# Development Assessment Panel

date of meeting: 01 Mar 2023

**Item: 05****Subject: DA2012 - 381.5 - MODIFICATION TO DESIGN OF PREVIOUS APPROVED SUBDIVISION AT LOT 12 DP 1226839 SUMMER CIRCUIT AND WHITEWATER TERRACE, LAKE CATHIE****Report Author: Development Assessment Officer (Planning), Patrick Galbraith-Robertson**

That DA2012 - 381.5 for a modification to design of previous approved subdivision at Lot 3, DP 1247192 (now known as Lot 300 DP1278057) & Lot 12 DP1226839, Summer Circuit and Whitewater Terrace, Lake Cathie, be determined by granting consent subject to changes to the following conditions:

Figure 3: Originally proposed Plan submitted with Modification Application - detailing changes to the laneway

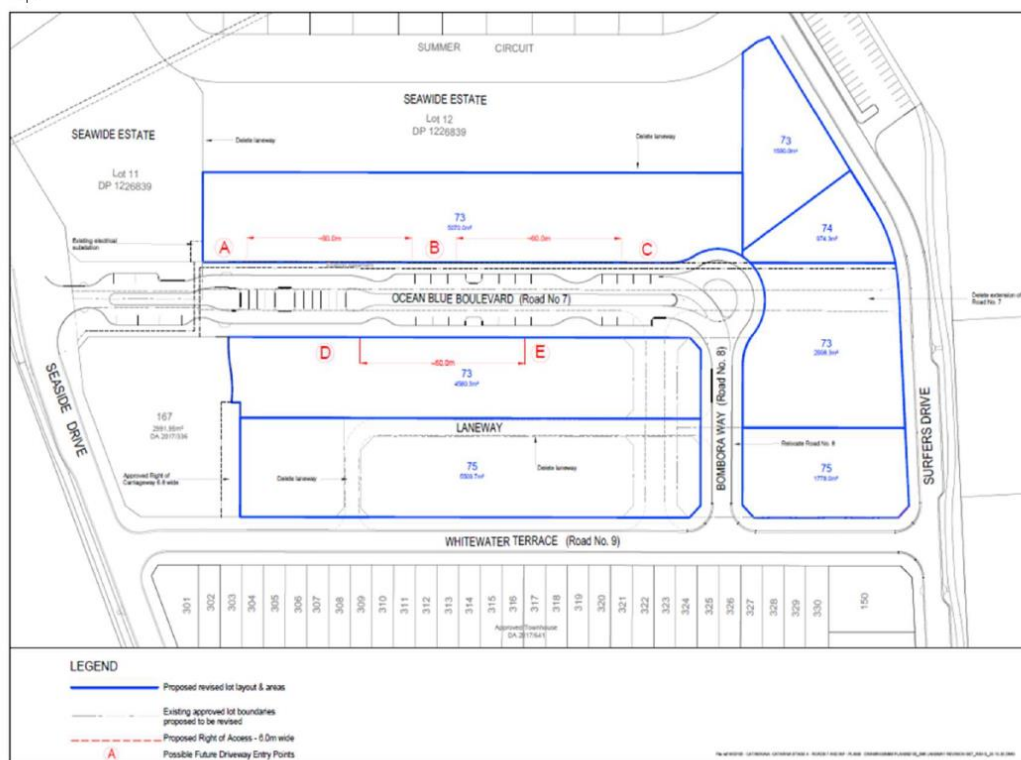
The modification application has been the subject of a lengthy assessment period to address key assessment issues. The proposal has been amended in this regard during assessment with the following key changes made:

1. Maintain the originally approved east-west ocean Blue Boulevard/main street;
2. Delete the previous Bombora Way connection between Ocean Blue Boulevard to Whitewater Terrace;

3. Delete the east-west mid-block laneways to the north and south of Ocean Blue Boulevard;
4. Provide new pedestrian north-south linkages between Ocean Blue Boulevard and Whitewater Terrace; and
5. Subdivide the land in a staged progression.

Figure 4: Revised Amended Subdivision Plan – removal of laneways and Bombora Way, Ocean Blue Boulevard

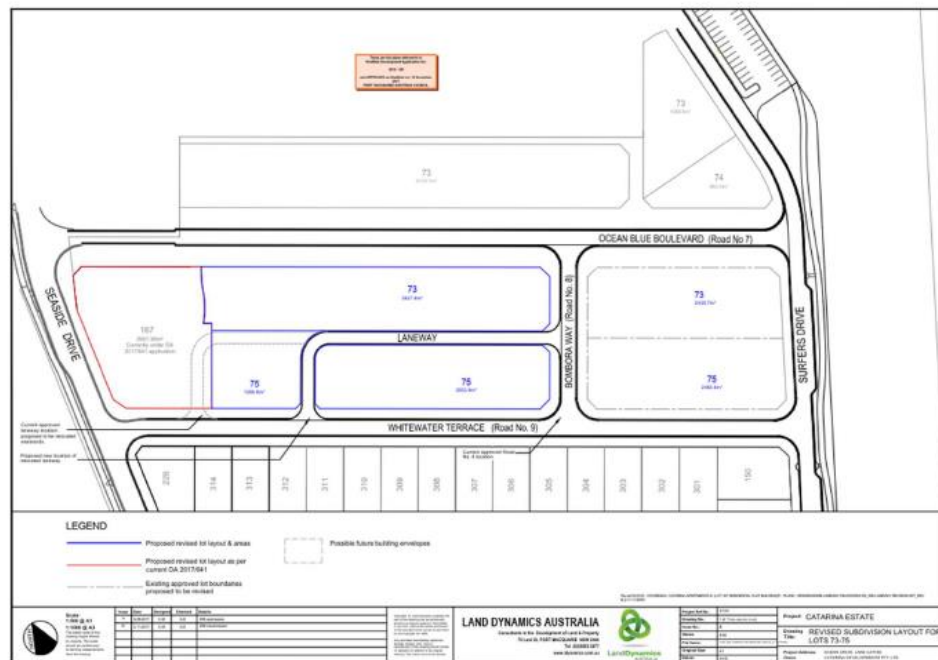
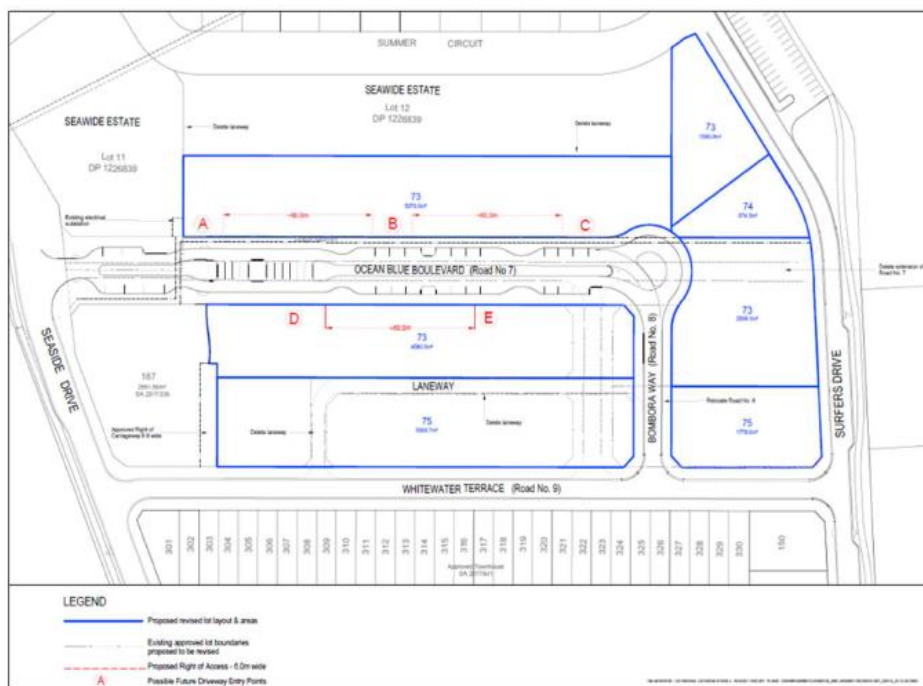
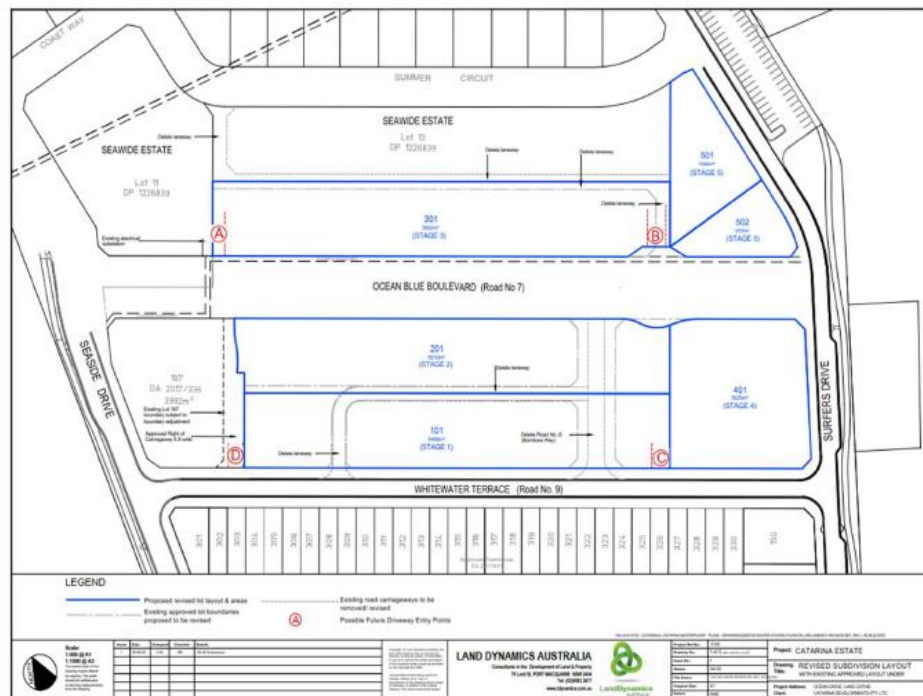
The originally approved Subdivision Plan is identified in **Figure 2**.

The originally submitted Modification plan, is identified in **Figure 3**.

This subdivision plan has been revised and is to be replaced with **Figure 4**. This plan shows the proposed revised subdivision layout, includes deletion of Bombara Way and laneways from the plans, connection along Ocean Blue Boulevard between Seaside Drive and Surfers Drive, and identifies the vehicular access points to the carpark basements.

Figure 5: Amended Plan with Amendments Annotated

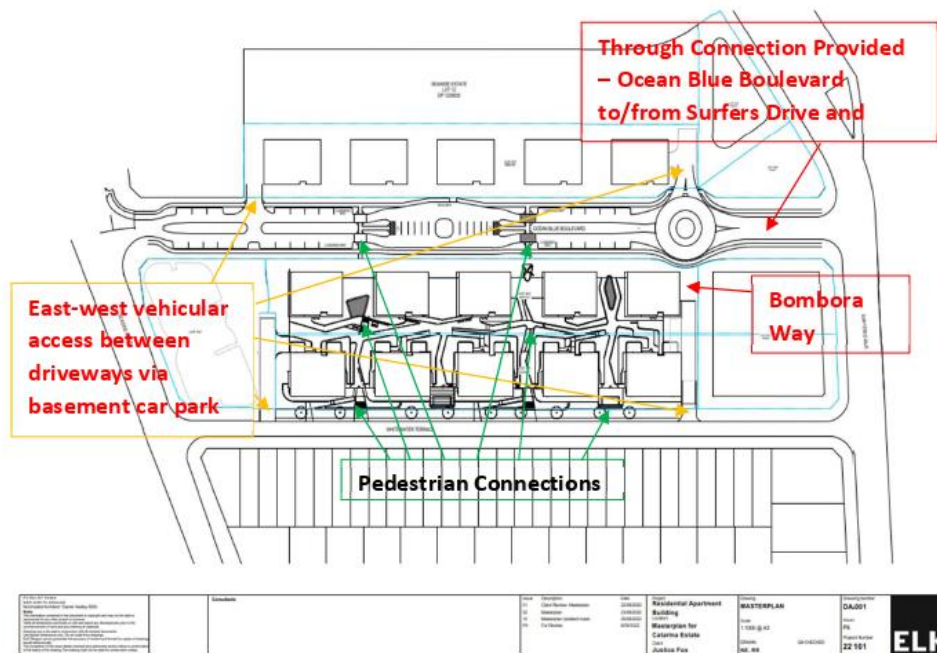
**Figure 5** provides an annotated illustration of the proposed amendments on the revised plan.

**Figure 6: Integrated Basement Carpark Access**

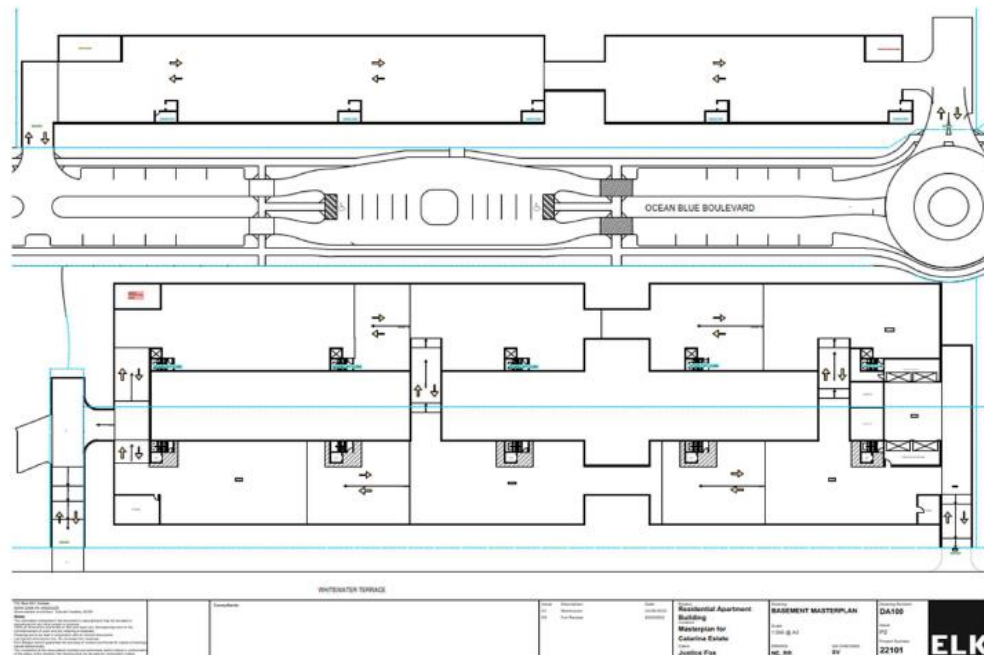
The proposed integrated basement carpark plan and vehicular ingress/egress access arrangements within the Catarina Hilltop precinct are identified in **Figure 6**.

The northern basement (Stage 3), proposed Lot 301 will be accessed from two (2) vehicular access points off Ocean Blue Boulevard located at the eastern and western end of the proposed apartment buildings/basement. The southern basement (Stages 1 and 2), proposed Lot 101 and Lot 102 will be accessed from two (2) vehicular access points off Whitewater Terrace. This integrated basement arrangement is shown in **Figure 6**.

The integrated basement arrangement would allow for waste collection from the basement entry turnarounds. It is likely that an on-street loading bay would be the most practical means of servicing the ground floor commercial premises on Ocean Blue Boulevard, and on-street loading bays have been incorporated along Ocean Blue Boulevard, refer to **Figure 6**.

Figure 7: Catarina Hilltop Village Roads & Pathways Connectivity

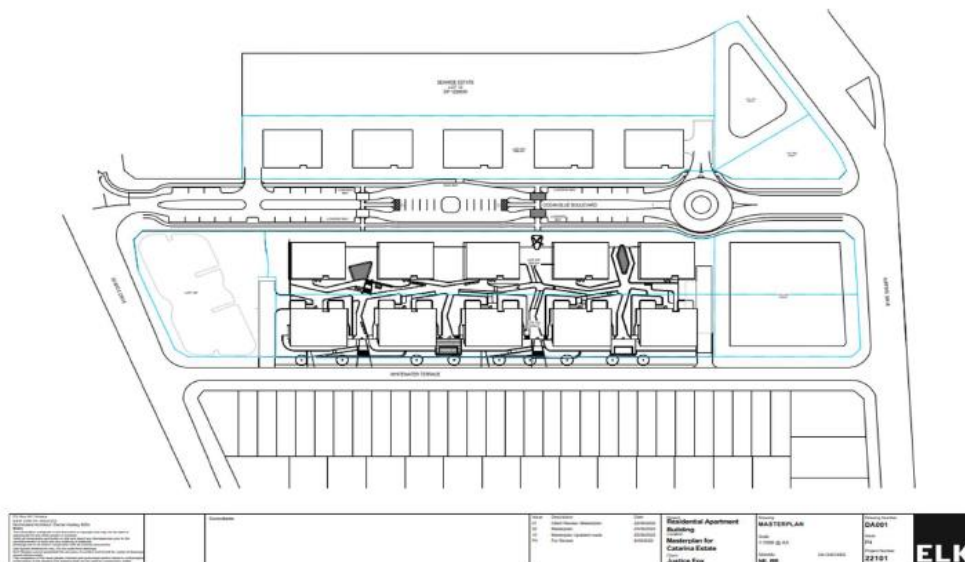
It is no longer proposed to close the eastern end of Ocean Blue Boulevard. Images of the amended road configuration, **Figure 4 - Figure 6** identify a through road/main street being Ocean Blue Boulevard connecting vehicular and pedestrian access east/west between Seaside Drive and Surfers Drive. It is noted from comments provided by PMHC at a Pre-lodgement meeting on 3 May 2022 relating to the future built form development application, that this amended road configuration is supported in principle. A copy of the Pre-lodgement Minutes is provided at **Annexure E**.

A public pedestrian linkage will also be provided between Ocean Blue Boulevard and Whitewater Terrace, to replace Bombora Avenue. This is to be achieved via appropriate easements through the Stage 1 (proposed Lot 101) and Stage 2 (proposed Lot 201) developments. It is likely that the legal mechanism to ensure public access to the pedestrian linkage would be an easement providing a public pedestrian pathway created under a condition of the future development consent/s for built form on the site. The easements would be expected to be created over the completed built form at ground level as an underground basement carpark sits beneath proposed Lots 101 and 201 buildings.

As the amendment provides for Ocean Blue Boulevard to connect directly through from Seaside Drive to Surfers Drive and connection with the Rainbow Beach car park, the further information regarding the timing and engineering detail regarding the alternate route along Bombora Way are no longer required. The design and construction approval process for the roads will ensure road gradients and access arrangements are appropriate and meet required engineering standards/compliance. The design and engineering details of Ocean Blue Boulevard and integrated basement have been further refined since the Pre-lodgement Meeting because of subsequent discussions with PMHC technical staff and consultant experts. The plans ensure appropriate vehicular and pedestrian connectivity for visitors and residents, disabled and commercial users within the Catarina Hilltop Village and surrounding area. As per **Figure 7**, proposed Lots 101 and 201 have detailed pathway and landscape connectivity as a DA will be subsequently lodged over proposed Lots 101 and 201 as supported by the staging proposal. This delivers Council and DPE certainty in the development design and provides pathways and connectivity throughout the Catarina Hilltop precinct in the absence of the ground level laneways.

Figure 8: Catarina Hilltop Village – Proposed Lot 1 Landscape and Pathway Connectivity Plan

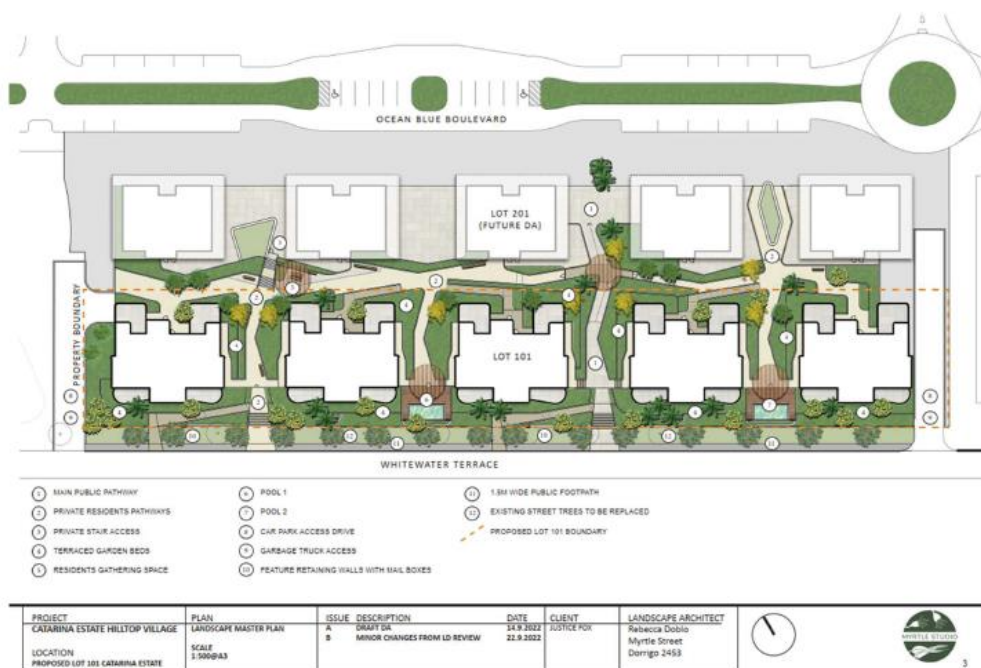
As **Figure 8** shows, pedestrian connectivity and circulation space will be maintained between the buildings at ground level, and a public access pedestrian pathway between Whitewater Terrace and Ocean Blue Boulevard will link residents and visitors to the commercial uses, residential accommodation, and public open spaces within the Catarina Hilltop precinct. These connected spaces and pathways are evidenced in the landscape plan for the development of proposed Lot 101 and shows the connectivity and circulation between and around buildings, and between proposed Lot 101 and Lot 201. The proposed plan considers the gradient differences in the ground levels between the lots, which can be managed and enhanced in the absence of the laneway which are to be removed as part of this modification. This holistic approach to the design of the Catarina Hilltop precinct provides a better urban design approach and improved amenity.

The proposal therefore deletes the east-west mid-block laneway to the north and south of Ocean Blue Boulevard between proposed Lots 101 and 201; and proposed Lot 301 and Lot 12 DP 1226839. As identified previously, to respond to Council's request to restrict access off Ocean Blue Boulevard so that numerous individual entry points to any development are avoided, and potential conflict between users is reduced; no direct vehicular access points are proposed on the southern side of Ocean Blue Boulevard into proposed Lots 101 or Lot 201. Vehicular access is located at each end of a below ground basement accessed off Whitewater Terrace. This basement provides through traffic flow between buildings and proposed Lots 101 and 201, instead of requiring the previously identified laneway.
